# RC-05 SCHEMATICS DRAWING I

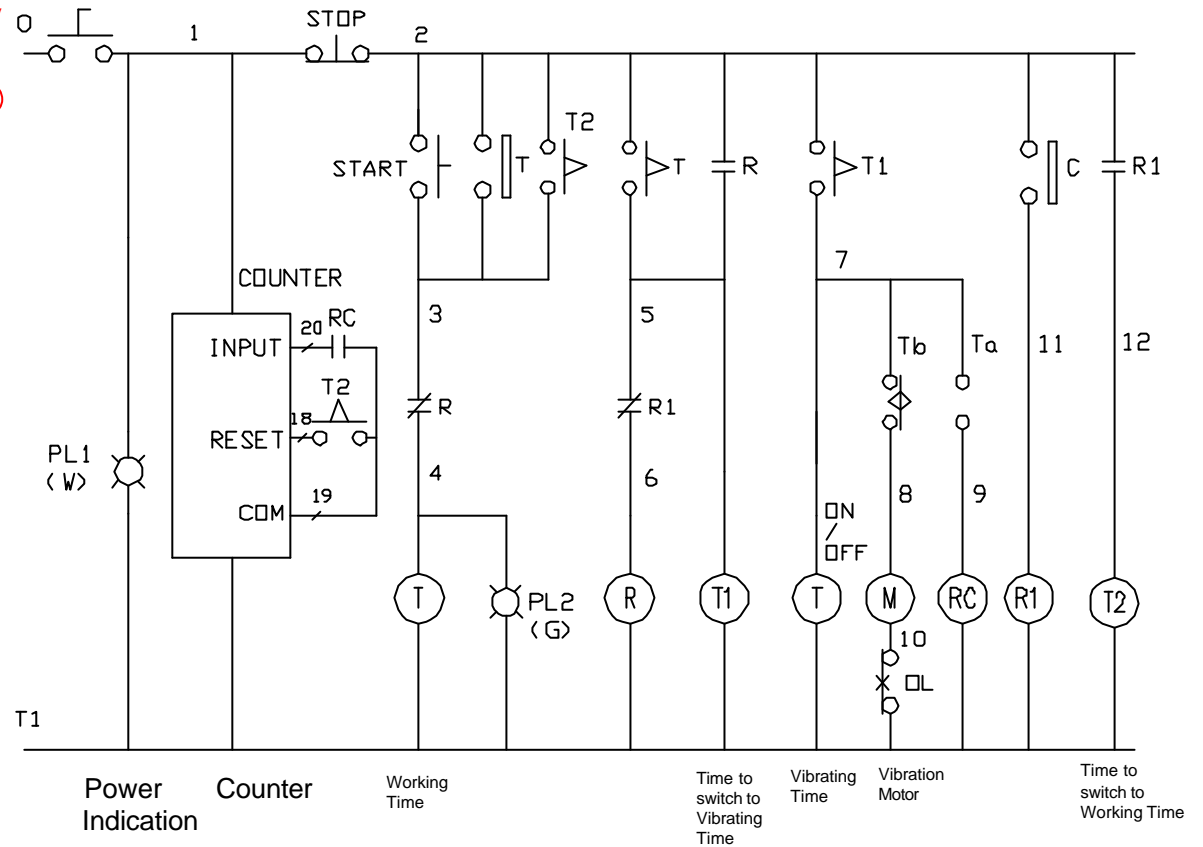
Replace the (3) Vibration Motors.

Simply change the transformer from 460V to 208V and connect the parts circled in **blue** back to its positions.

Ensure that R2 is connected to 220V

If 208V is not shown on transformer, please connect to 220V or 230V.

208V = 220/230V on the transformer.
